DEPARTMENT OF
CITY PLANNING

Decision Date: September 1, 2022

AA-2020-6052-PMLA-SL-HCA

738 N. Maltman Avenue

PRELIMINARY PARCEL MAP NO. AA-2020-6052

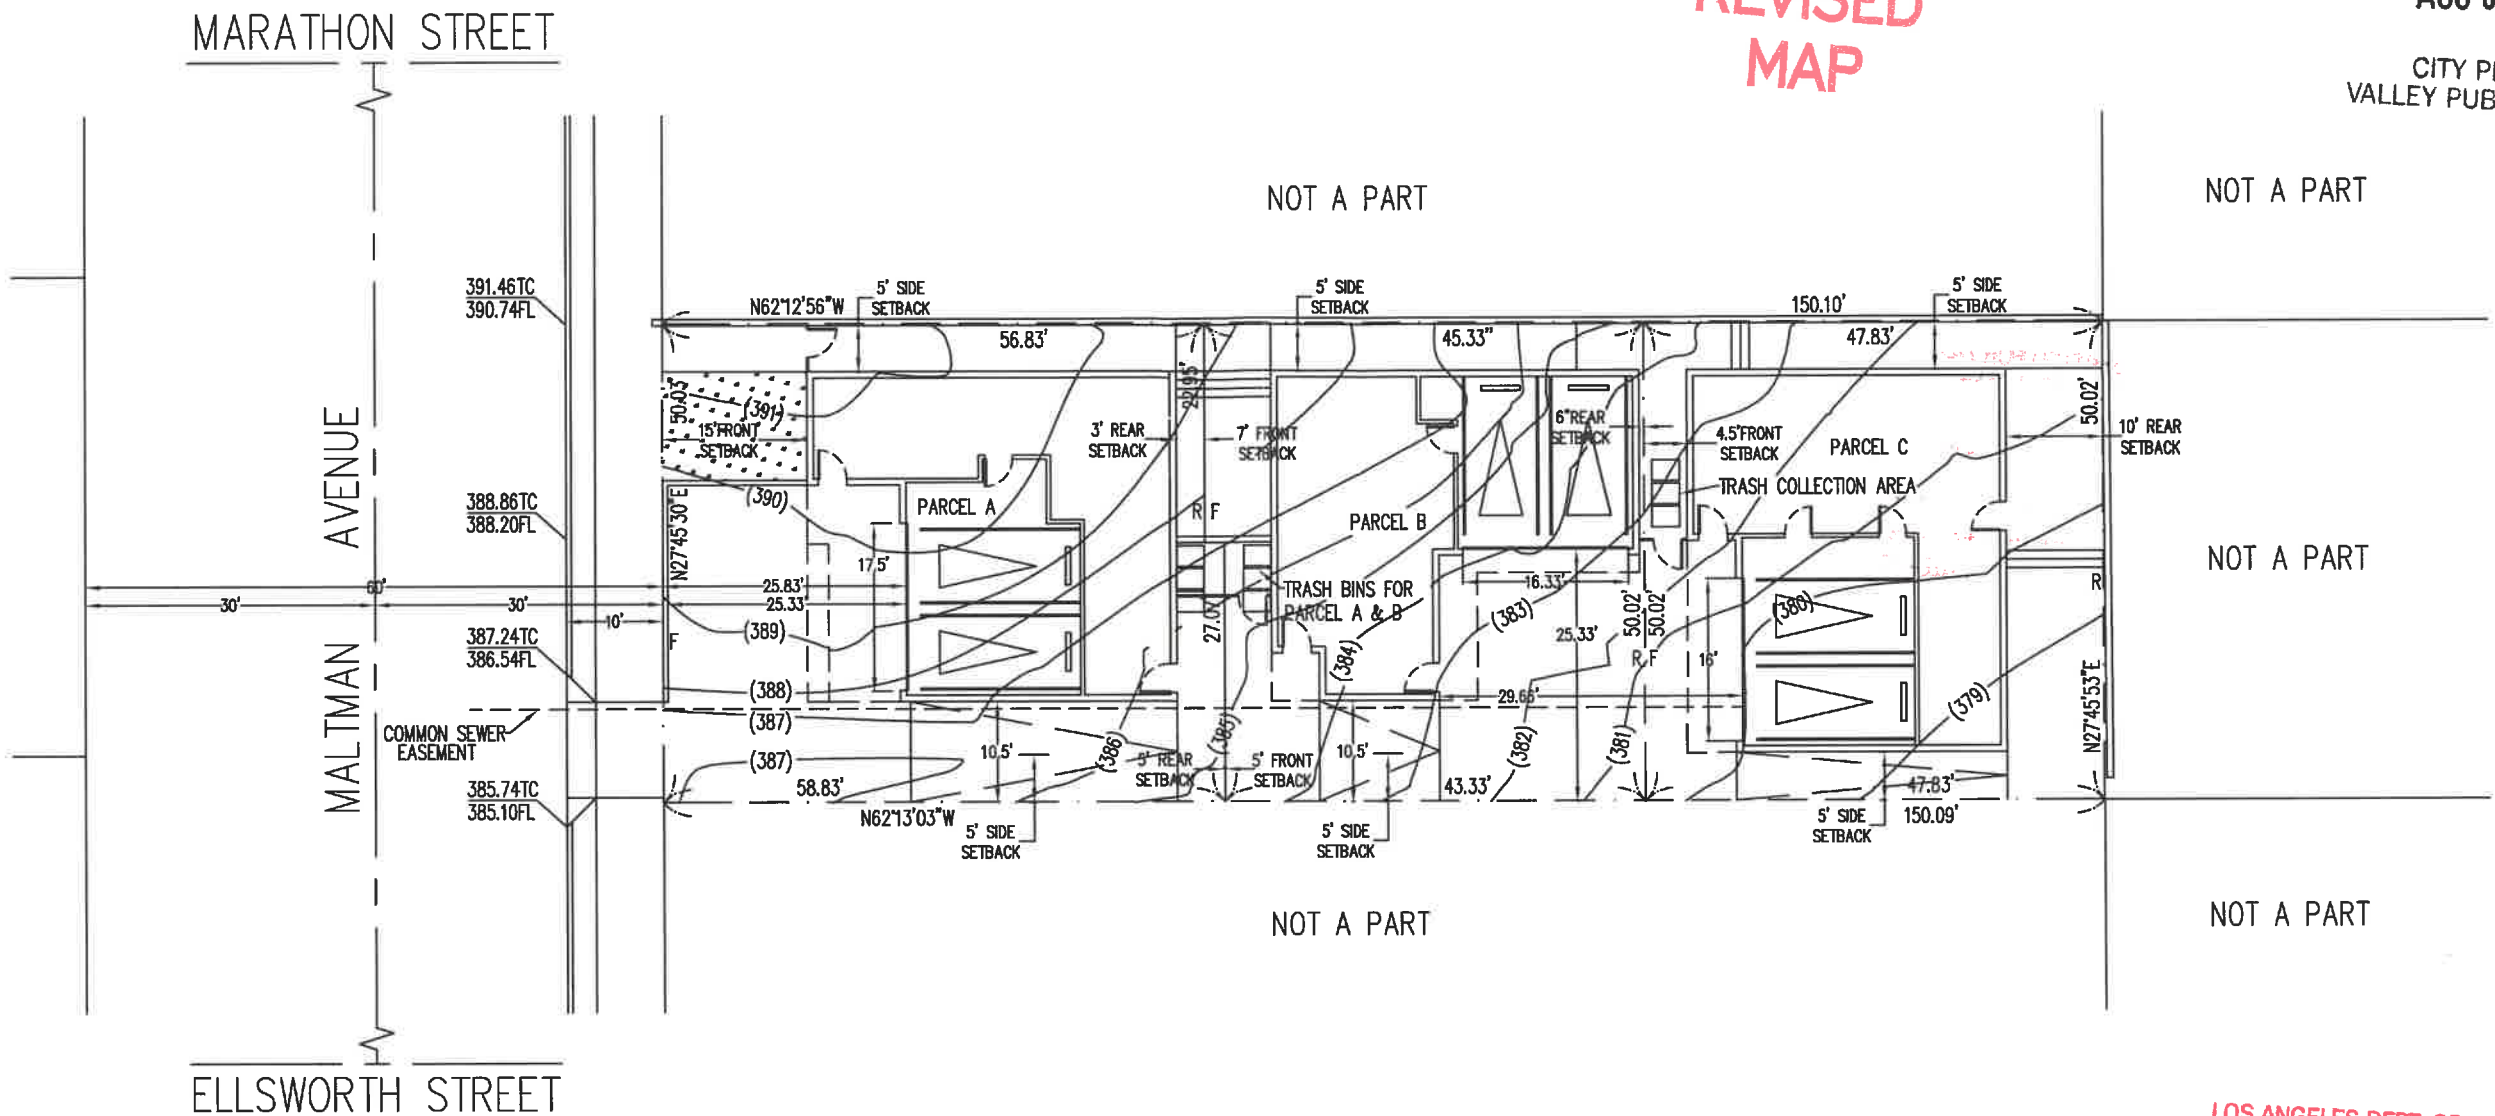
- c. The submitted plot plan is not complete. Provide a plot plan drawn to scale that accurately dimensions the property lines required yards on the site.

There is a 15 ft. Building Line along Maltman Avenue on this Subdivision.

Setback Matrix				
Lot No.	Front (E)	Rear (W)	Side (N)	Side (S)
A	15-0'	3-0'	5-0'	5-0'
B	5-0'	0-6"	5-0'	5-0'
C	4'-6"	10'	5-0'	5-0'
